HISTORIC PRESERVATION COMMISSION STAFF REPORT

Address:	35 Oxford St., Chevy Chase	Meeting Date:	5/9/18
Resource:	Non-Contributing Resource Chevy Chase Village Historic District	Report Date:	5/2/18
Review:	HAWP	Public Notice:	4/25/18
Case Number:	35/13-18J	Tax Credit:	n/a
Applicant:	Gregory and Alicia Fishbein	Staff:	Dan Bruechert
Proposal:	Window Replacement

PROPOSAL:

The applicant proposes to enlarge the existing window well at the front right of the house for egress purposes.

Figure 1: 35 Oxford St.

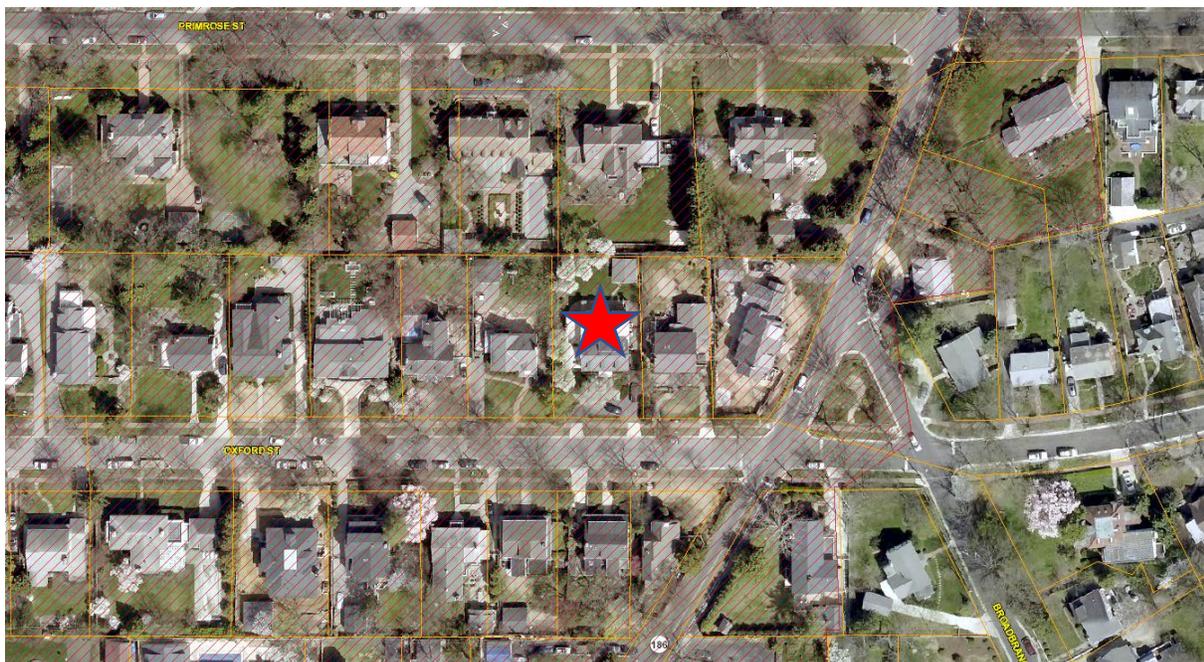
The applicant proposes expand the existing window well at the front-right corner of the building to accommodate egress needs. Staff finds that this proposal will result in a minimal visual change and will not impact the historic character of the building and recommends approval.

DRAWING TITLE:
 WINDOW WELL
 DETAILS
 TWO PANEL
 OPTION

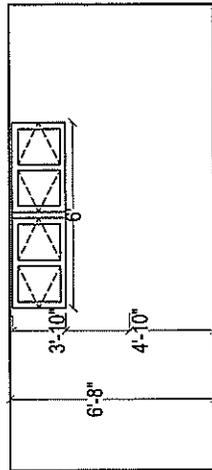
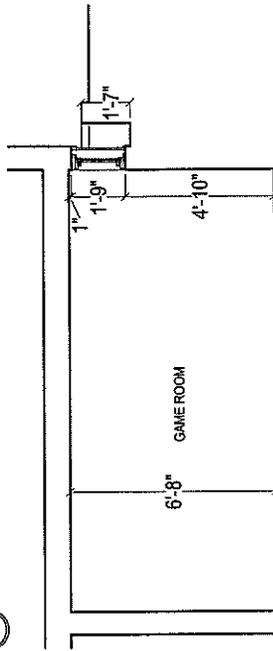
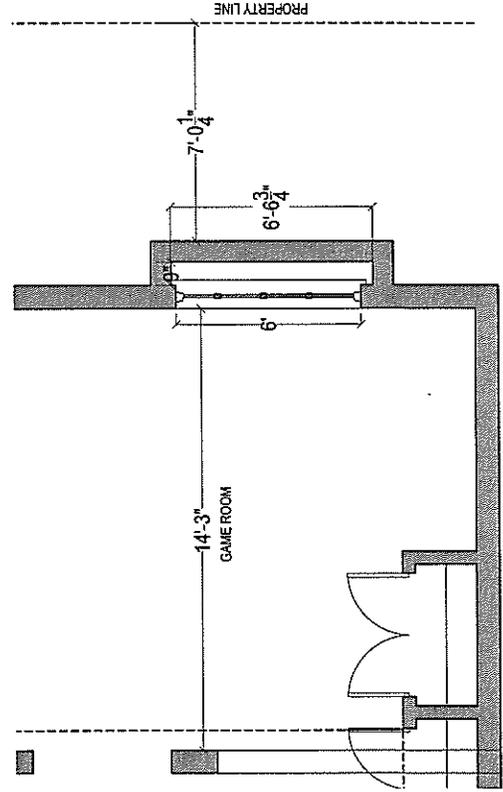
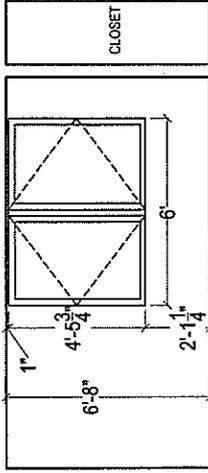
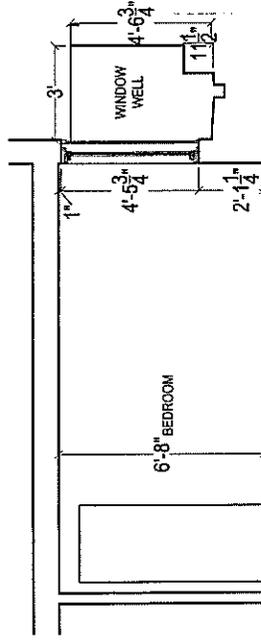
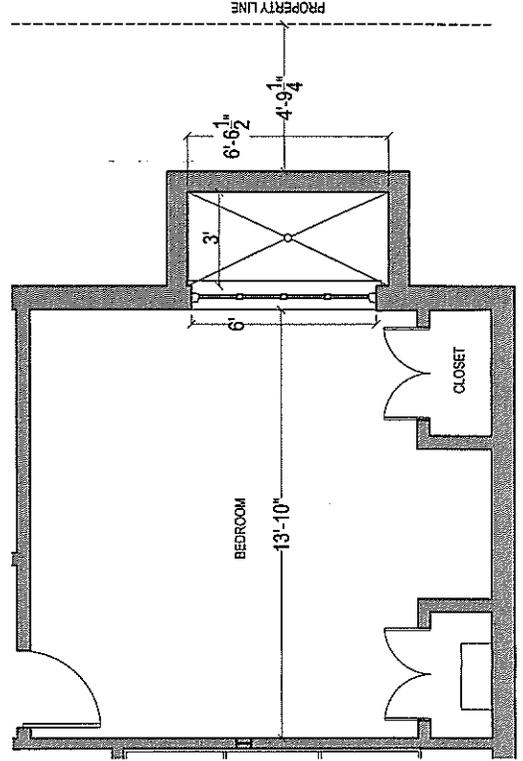
The existing window well is constructed out of concrete with a brick surround. It provides some natural light to the basement, but is only 9” (nine inches) wide and 1’ 7” (one foot, seven inches) deep and is not appropriate for egress purposes. The window in the well is a wood two-lite horizontal casement and is 1’ 9” (one foot, nine inches) high.

The applicant proposes to expand this window well so that it is appropriate for egress purposes. The existing window well will be widened from its existing 9” (nine inches) to a code-compliant 3’ (three feet). The well will be excavated from its 1’7” (one foot, seven inch) depth to 4’ 6 ¾” (four feet, six and three-quarters inch). In order to allow for egress, the existing window will be replaced with a Marvin wood window that is 6’ (six feet) wide and 4’ 5 ¾” (four feet, five and three-quarters inch) tall. The new window well will have a brick surround that matches the appearance of the existing (this information was not included in the application materials, but Staff has verified this with the applicant).

Staff finds that the only change in appearance to this feature that is visible from the public right-of-way will be the larger brick surround for the enlarged opening. Staff finds that while there are no *Guidelines* directly on point for this issue, the proposal complies with 24A-8(b)(1) in that it does not substantially alter the exterior features of the house. Staff further finds the visible materials of this proposal are compatible with the house surrounding district. Staff finds that the proposed wood window is appropriate per the *Guidelines*. Staff supports approval of the proposed window. The brick surrounding the window well will be the most prominent feature

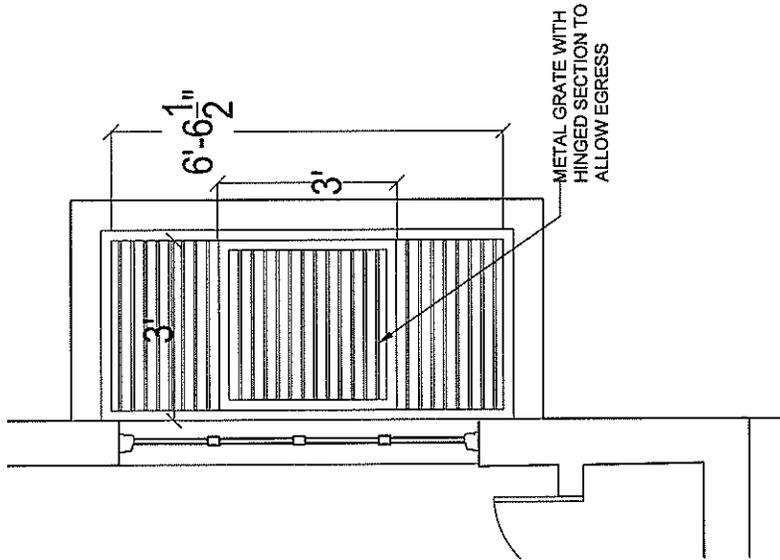
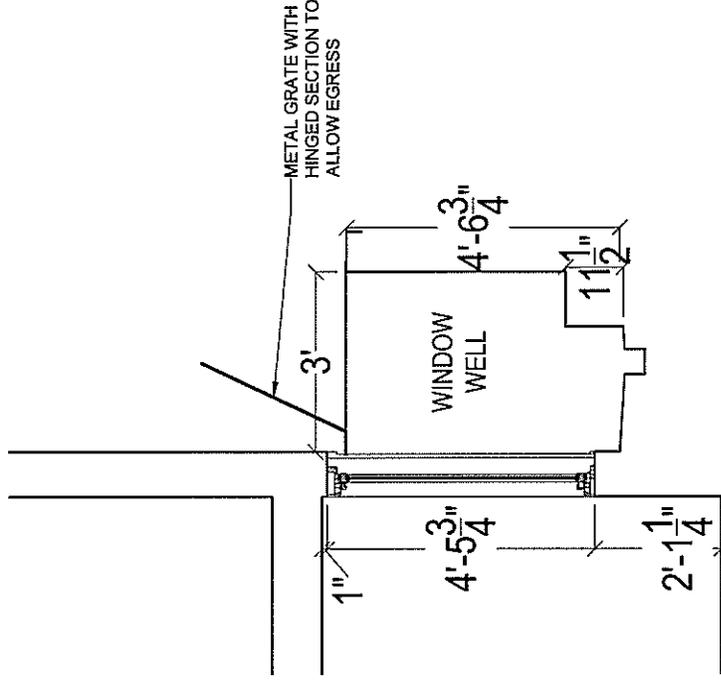
The applicant is proposing to install a custom metal grate over the enlarged windows well. This feature will provide safety over the new feature, while still allowing for egress. A metal grate is an appropriate material for this feature and as it will be at grade, it will not be visible from the public right-of-way and Staff supports its approval.

1. The proposed window will be the same wood Marvin window type used under the previously approved HAWP for the new second story window
2. The window well will be brick lined so as to match the existing façade
3. The window well cover will be a custom metal hinged grate, detail attached.
